RAI 03.07.02-24, Supplement 1, Revision 1**QUESTION:****Follow-up Question to RAI 03.07.02-15 (STP-NRC-100036)**

UHS Basin and RSW Pump House:

RSW Piping Tunnel:

Figure 3H.6-245: Active Lateral Earth Pressure Diagrams for Typical Section of RSW Tunnel

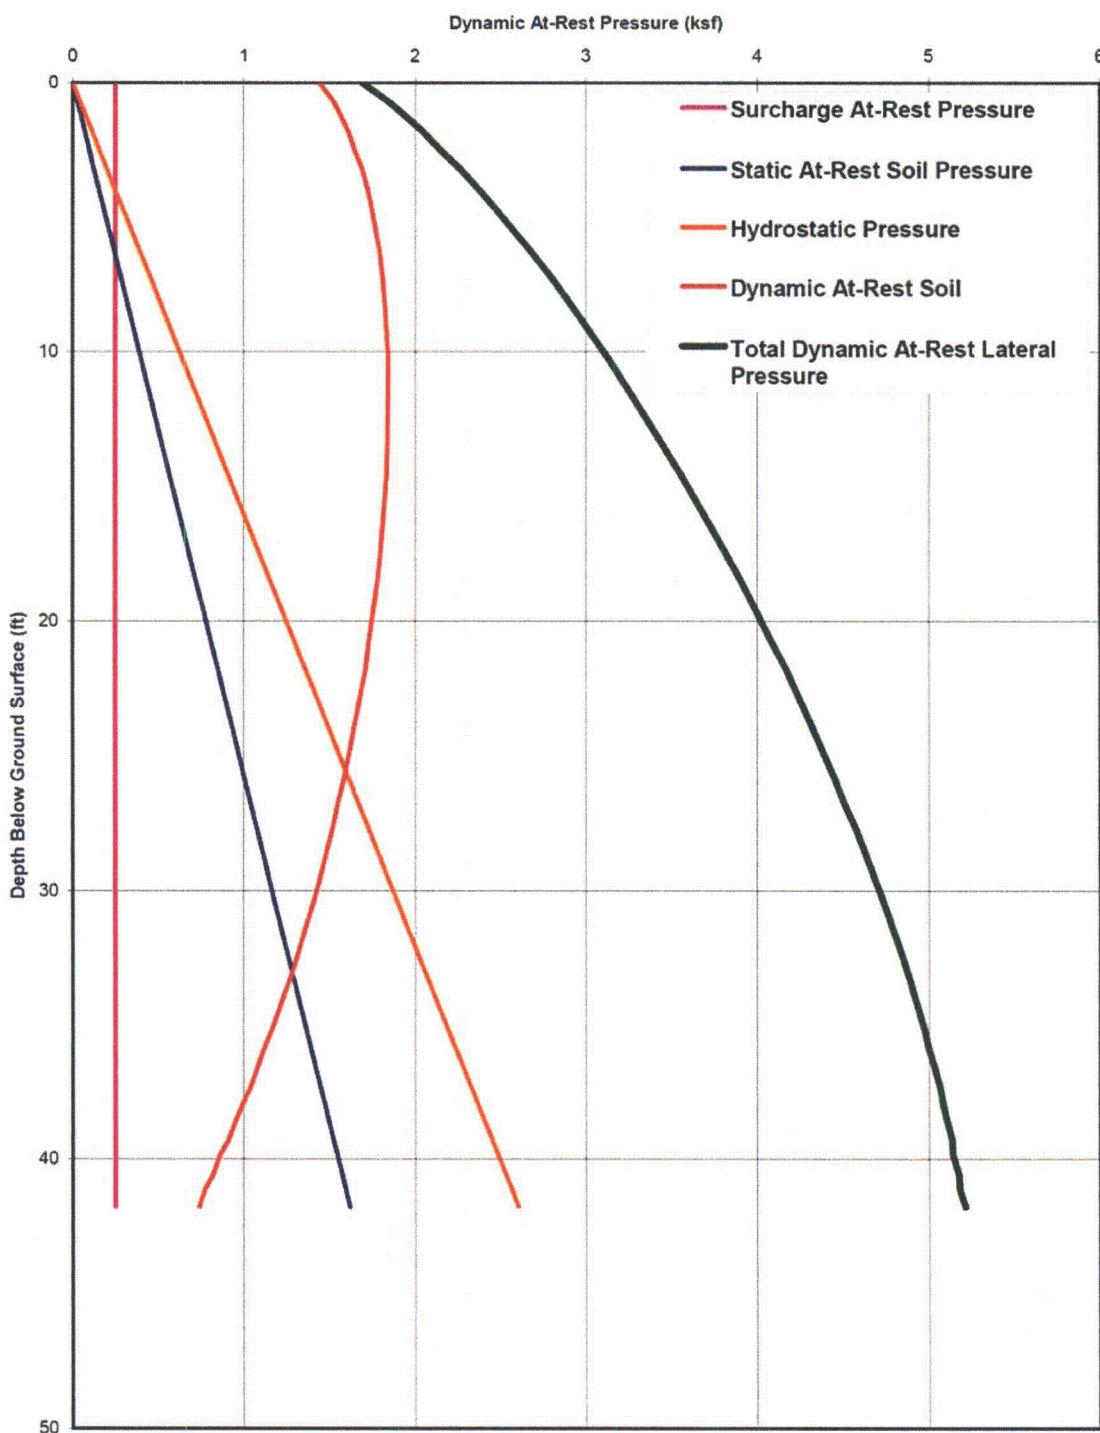
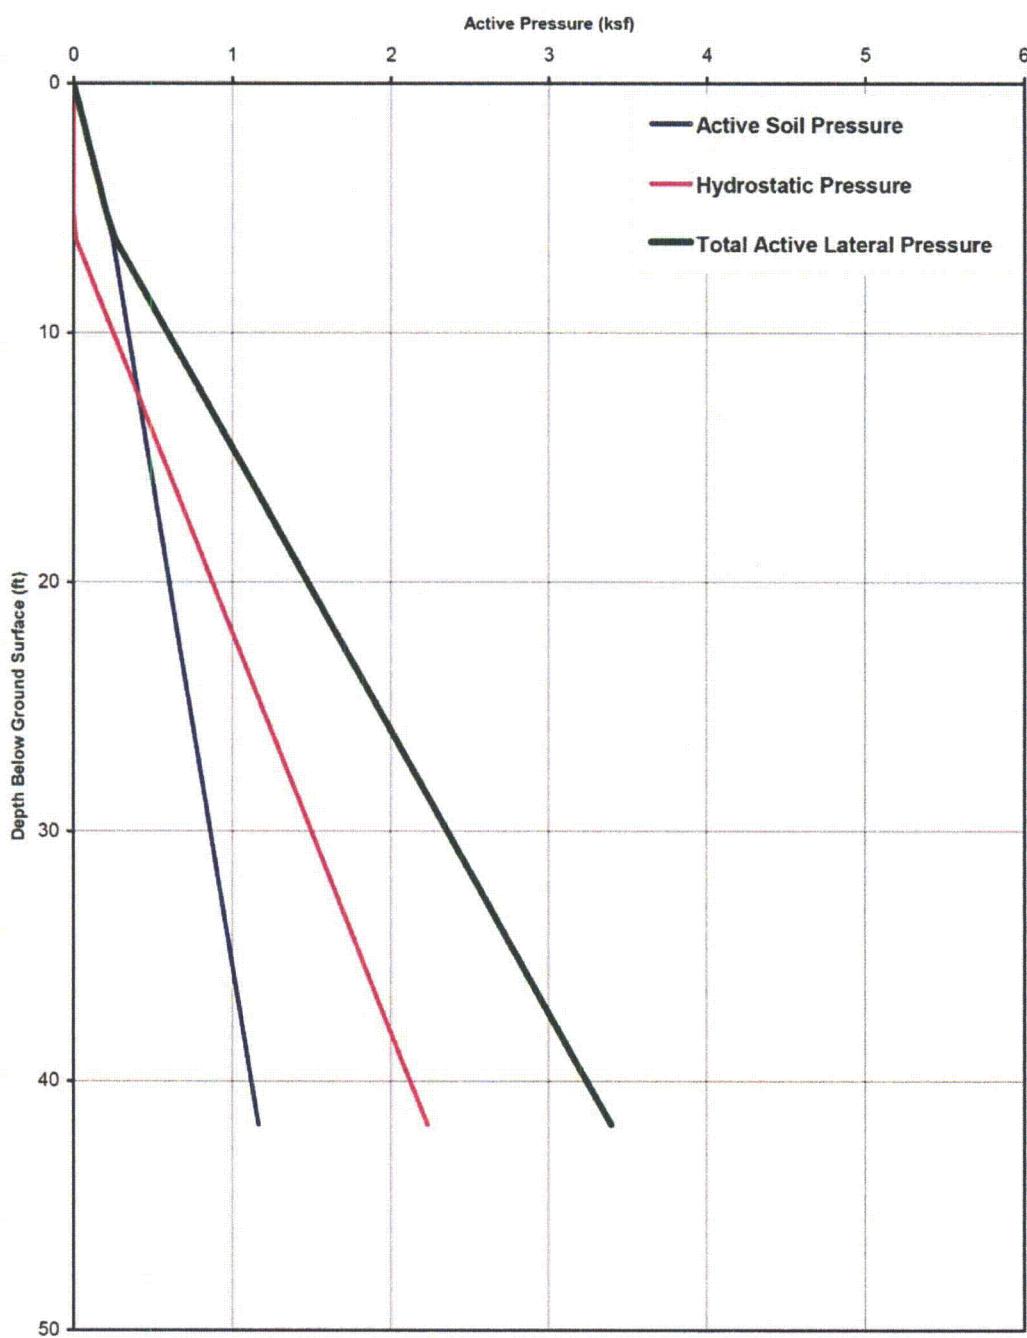
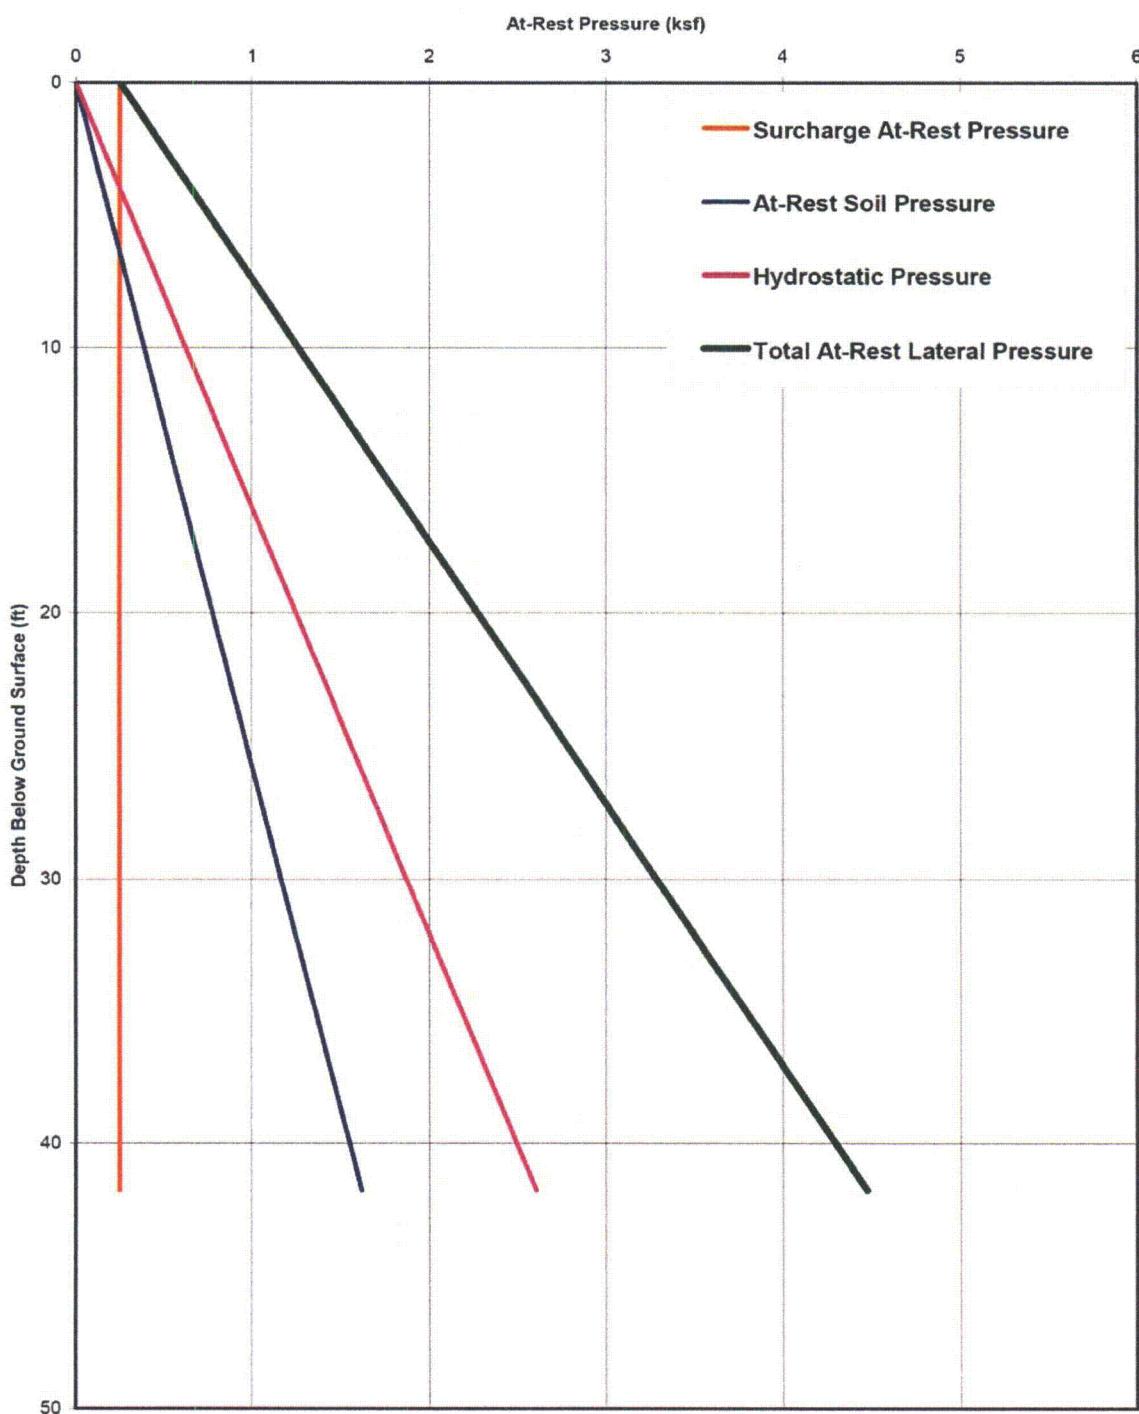
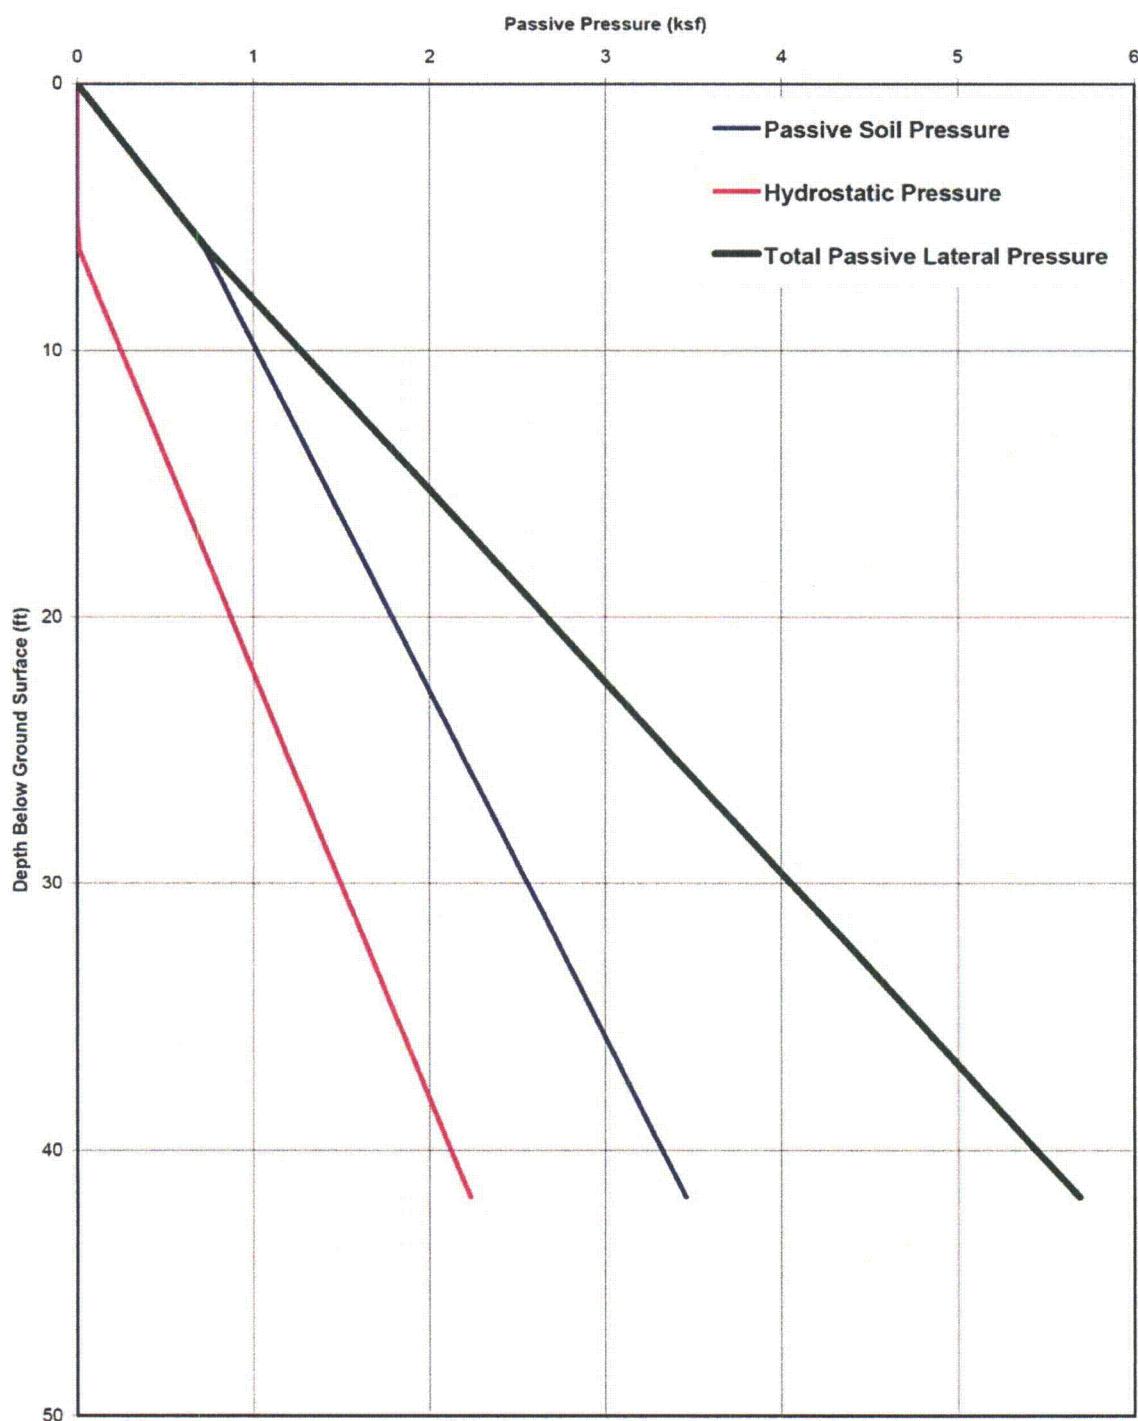
- b) For the staff to conclude that the design of structures with deep foundations, such as the Reactor Building (RB) and Control Building (CB), is satisfactory for the site, the site-specific design loads are needed to compare with the design loads used for the DCD. Lateral soil pressure is one such load. Therefore, please provide the lateral soil pressures for the RB and the CB, and compare these calculated pressures with those used in the ABWR standard plant design. Please also confirm if the effects of adjacent structures are considered in computing the lateral soil pressures, and if not, provide the justification for not doing so.

The SSSI incremental seismic soil pressure curves for the Reactor Service Water (RSW) Tunnel have been provided in COLA Part 2, Tier 2, Figures 3H.6-212 through 3H.6-217, in the response to RAI 03.07.02-24, Supplement 1, Revision 1, which is being submitted concurrently with this response. The at-rest, dynamic at-rest, active, and passive soil pressure profiles are provided in Figures 3H.6-44, and 3H.6-245 through 3H.6-247, included in Enclosure 1 of this response.
